**ADDENDUM NO. 2
 FOR
 S5K145 – CAMPBELL MS – ROOF REPLACEMENT, PHASE 2**

DATE: 9 February 2021
TO: All Prospective Contractors
FROM: Raymond Engineering–Georgia, Inc.
RE: S5K145 – Campbell MS Roof Replacement, Phase 2

SHEET TITLE: NEW ROOF PLAN
 A-101

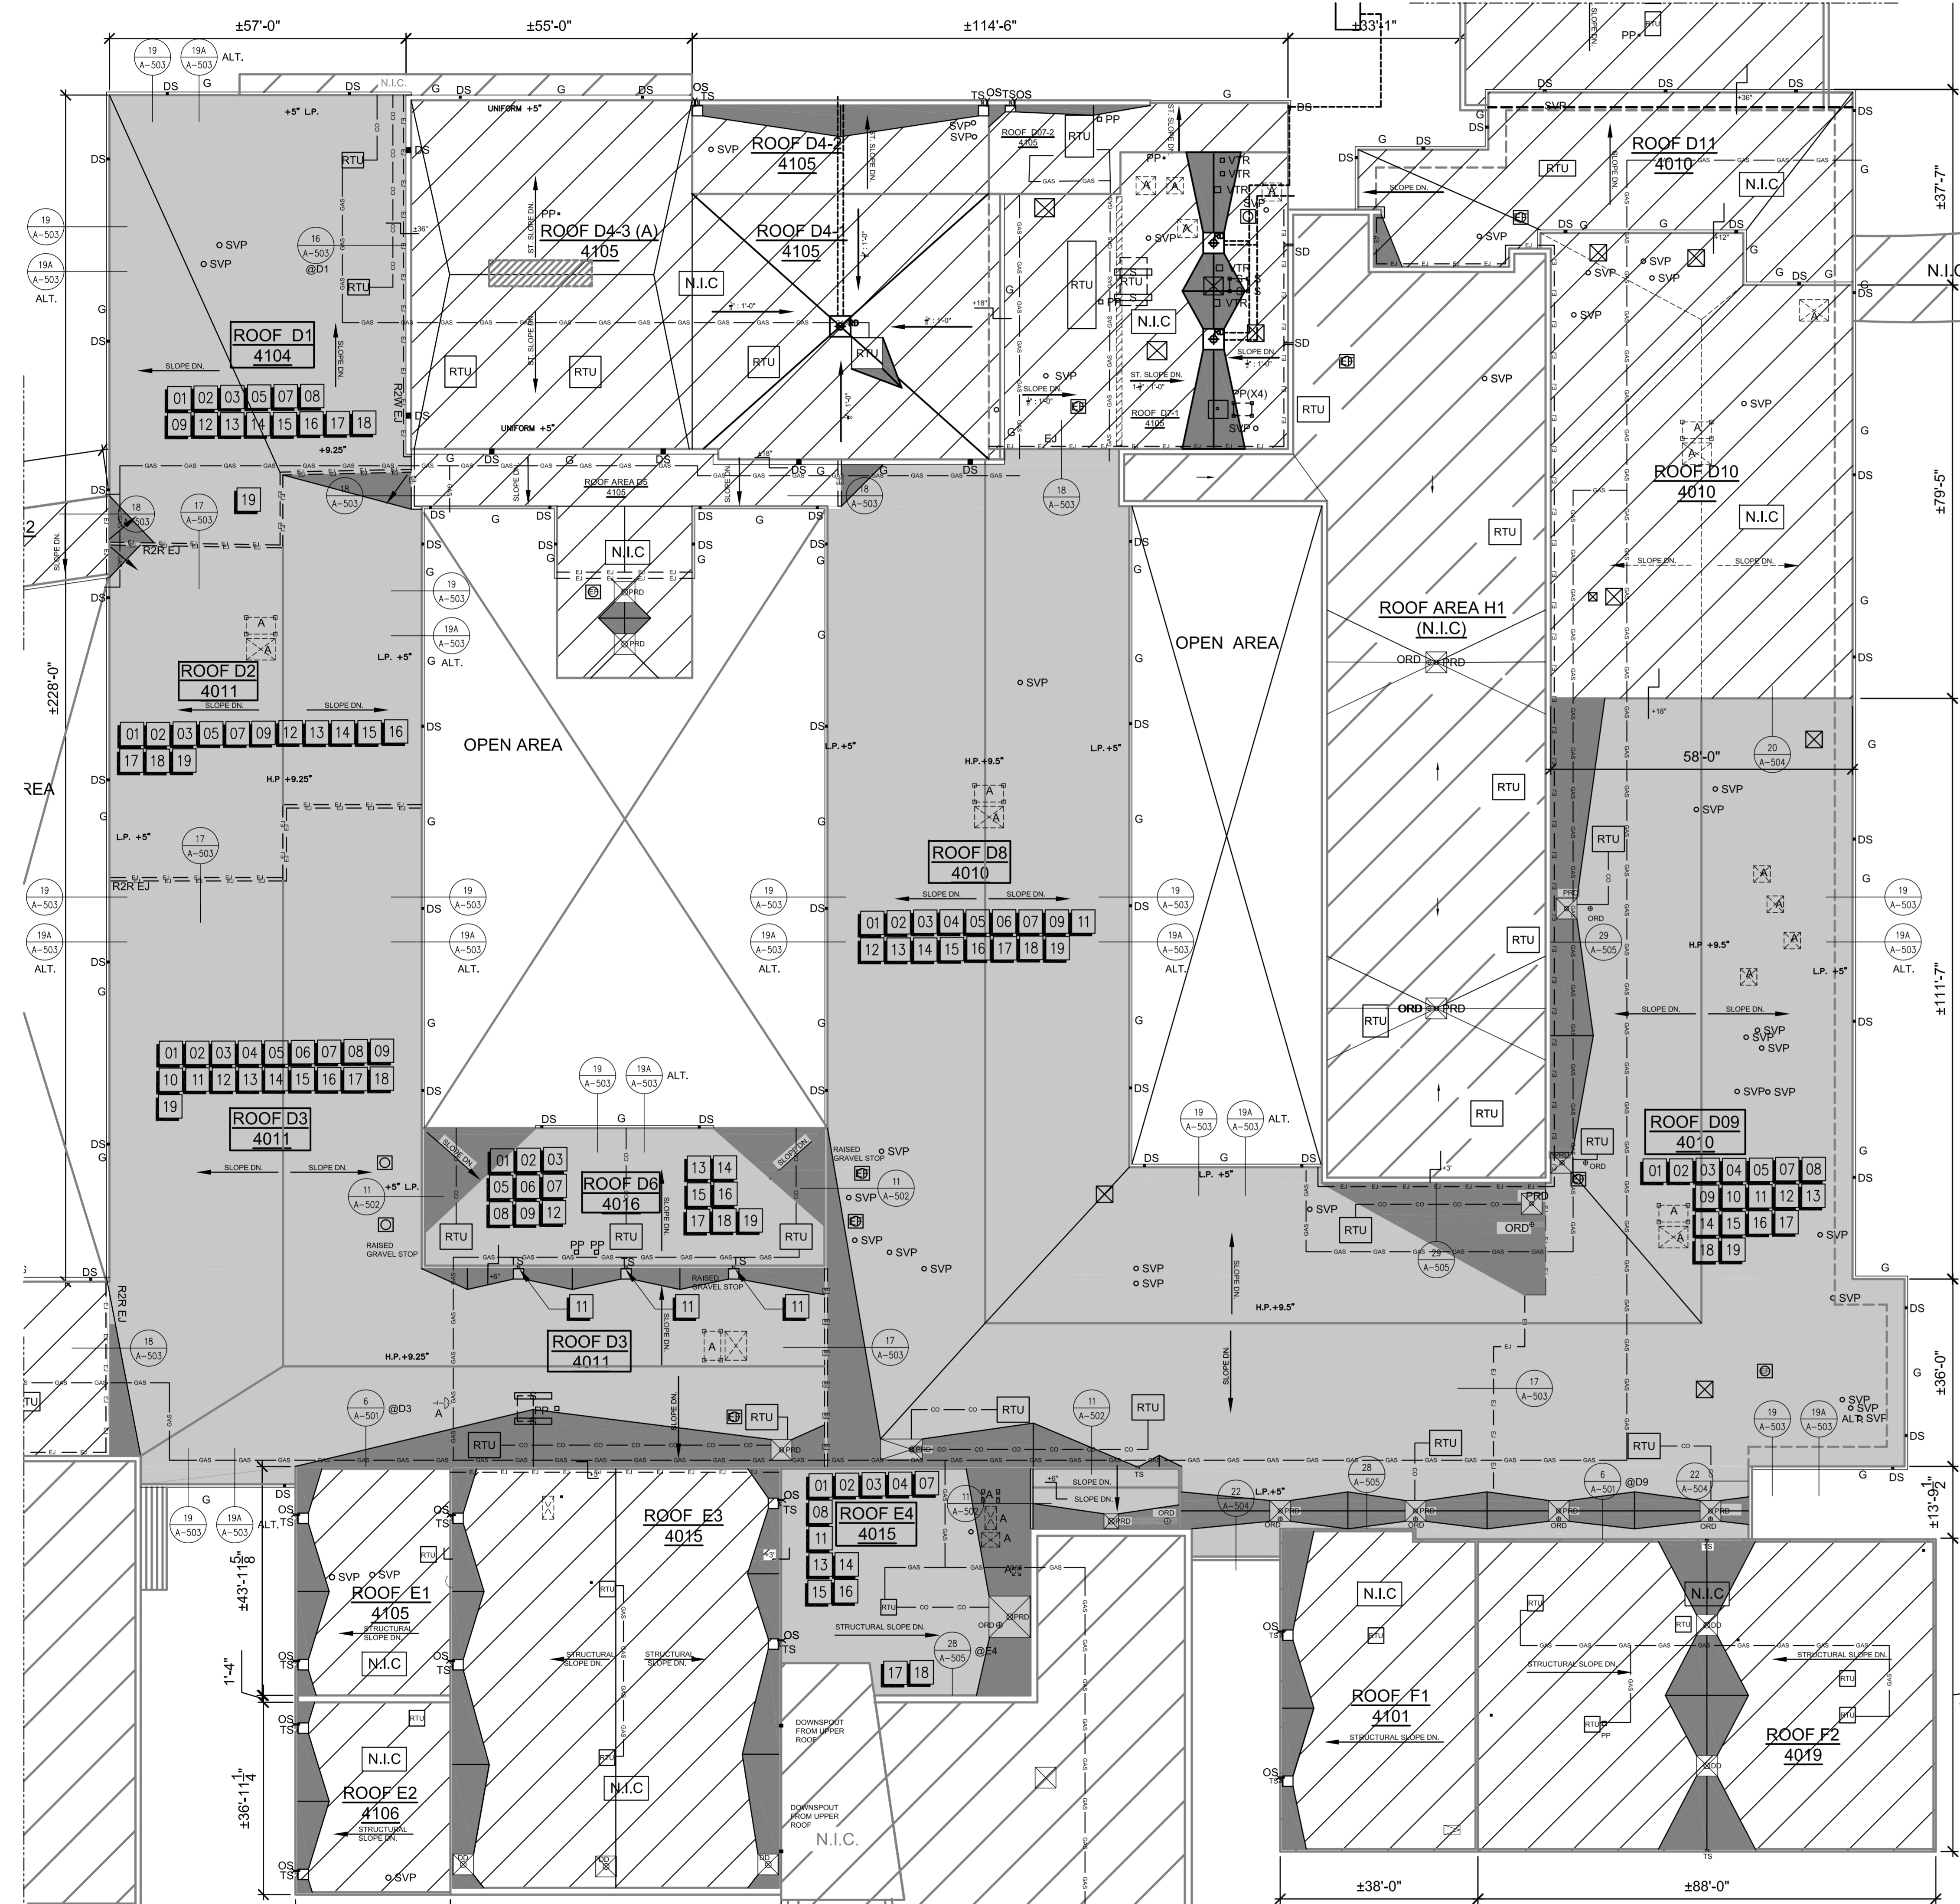
ARCHITECTURAL		
Delete:	Note 15, sheet A-101 and Note 13, sheet A-102.	Date: February 09, 2021

- Delete Note 15, sheet A-101 and Note 13, sheet A-102.
